January 26, 2024

Attachments to Addendum 2

LOWER CODDLE CREEK PARALLEL INTERCEPTOR PROJECT

1. Sheet C-2

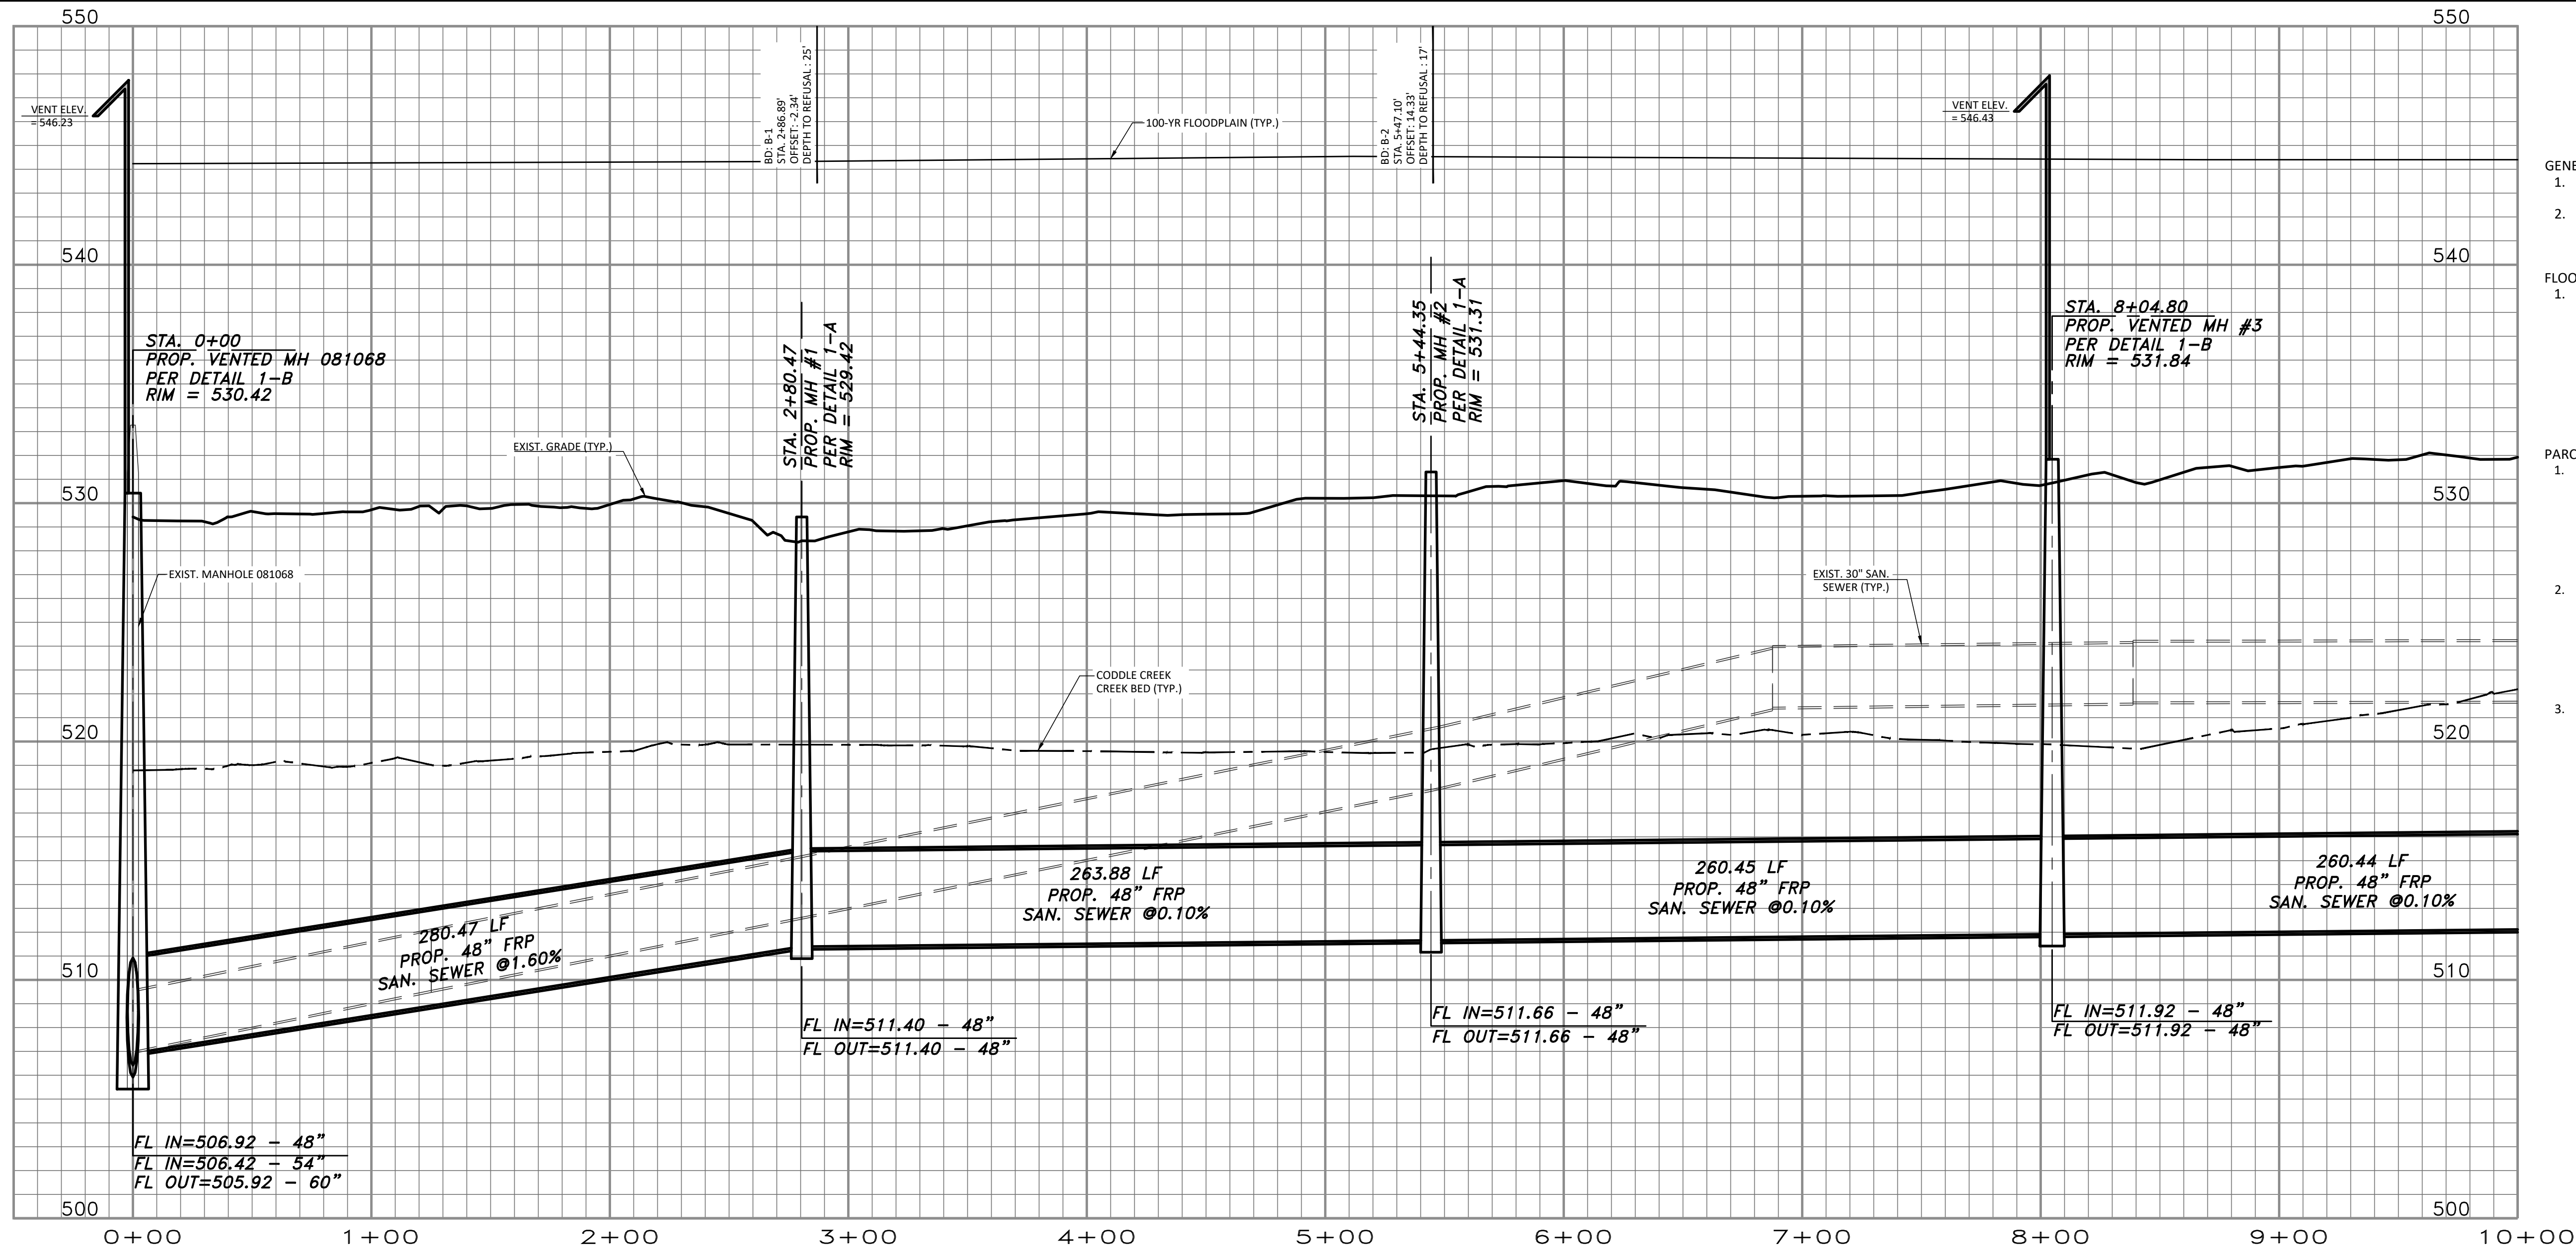
REPLACE plan sheet with attached revised sheet C-2.

Explanation: In “Recorded Easement Table” Parcel 72 information was revised and Parcel 72T was added. In “Phase 2 Easement Information” Parcel 72 information was removed and Parcel 72T was added.

Sheet: SS-2

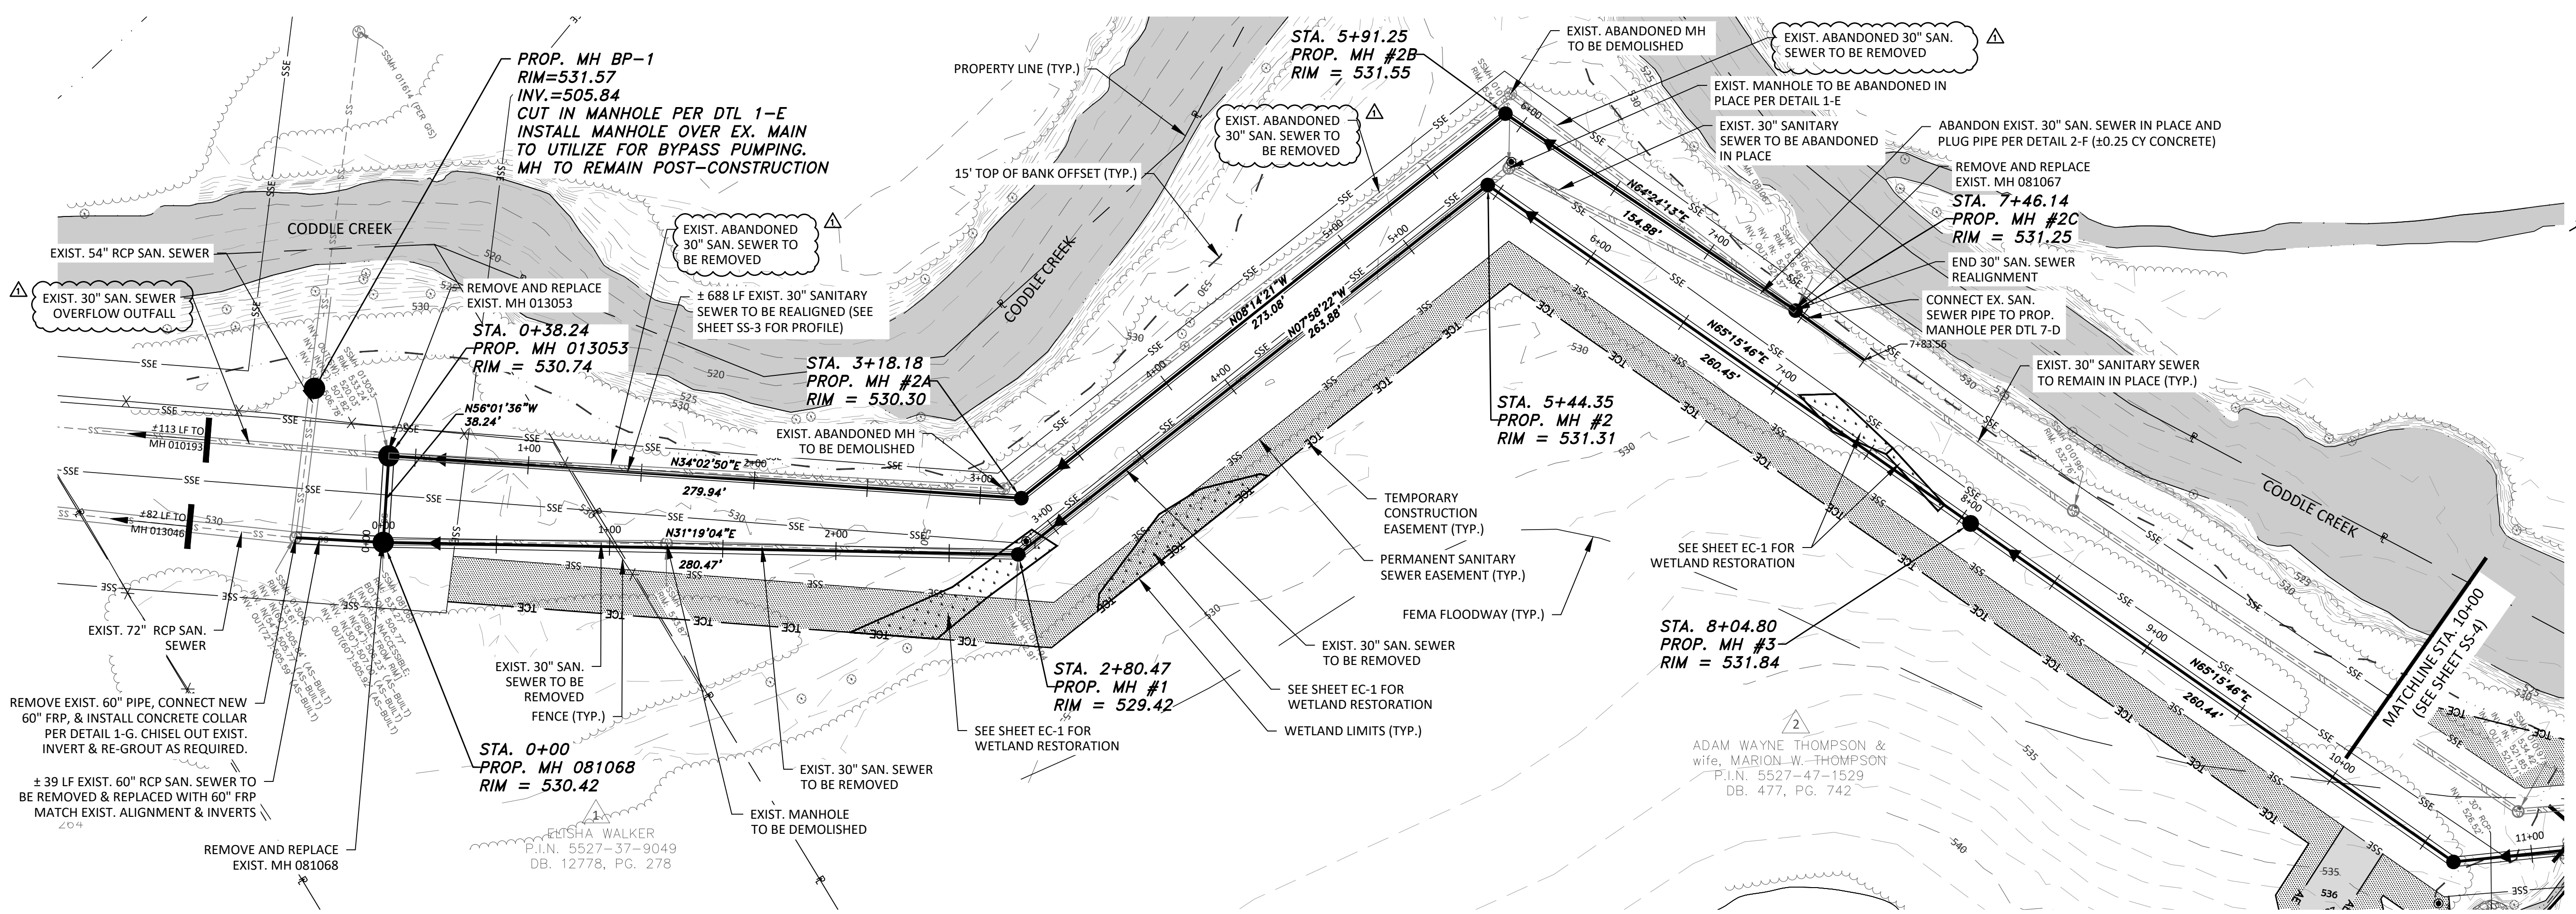
REPLACE plan sheet with attached revised sheet SS-2.

Explanation: Clarification added to various labels referencing existing abandoned 30” gravity sewer main.
